COUNTY OF MENDOCINO
DEPARTMENT OF TRANSPORTATION

ADDENDUM NO. 1 ACKNOWLEDGEMENT

TO: Plan Holders and Bidders
FROM: Alex Straessle, Engineer II
RE: SOUTH COAST LANDFILL FINAL CLOSURE CONSTRUCTION PROJECT,
DOT CONTRACT NO. 250042

Table 1. Specified Aggregate Infill Grain Size Distribution

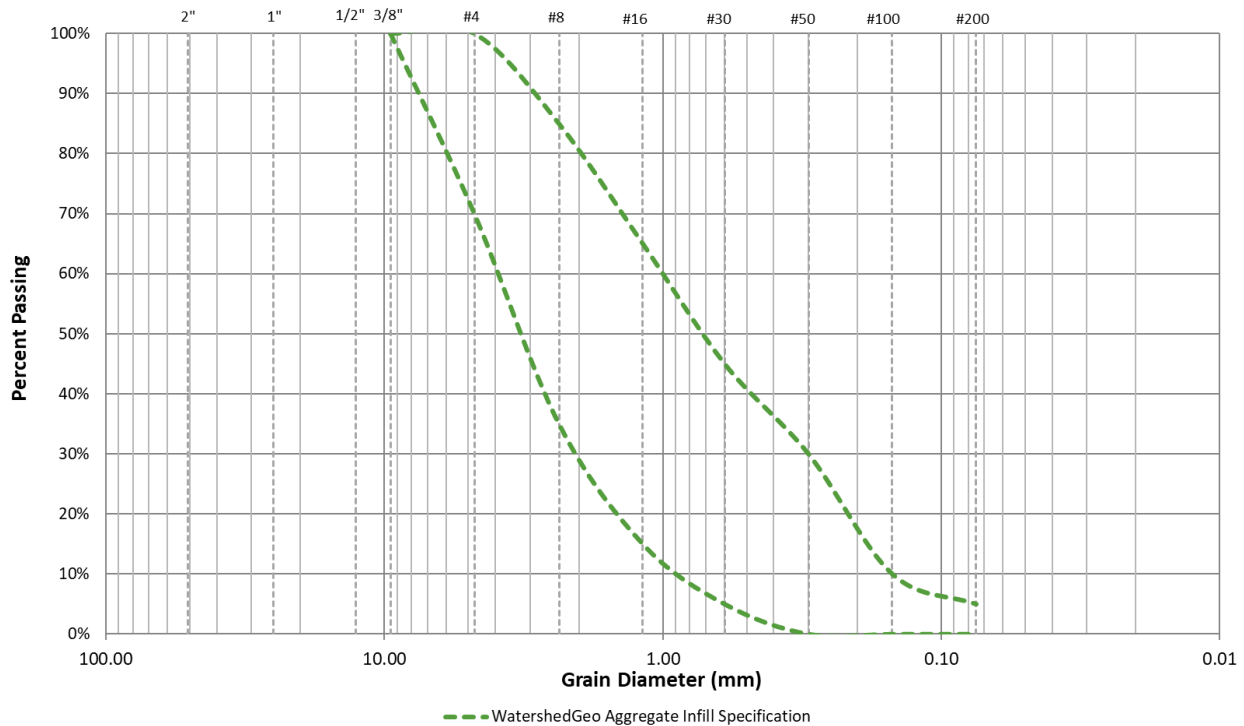
Replace Subsection 96-2.02.06 Sand Infill with the following:

Sand Infill Component of the Closure Turf® System shall meet the fine aggregate angularity, specific gravity, and grain size distribution as specified by WatershedGeo and as described in this Specification.

1. Specified aggregate infill grain size distribution shall be tested in accordance with ASTM C 136 / AASHTO T 27, Standard Test Method for Sieve Analysis of Fine and Coarse Aggregates. . The grain size distribution shall be as prescribed in Table 1 and shown in Figure 1.
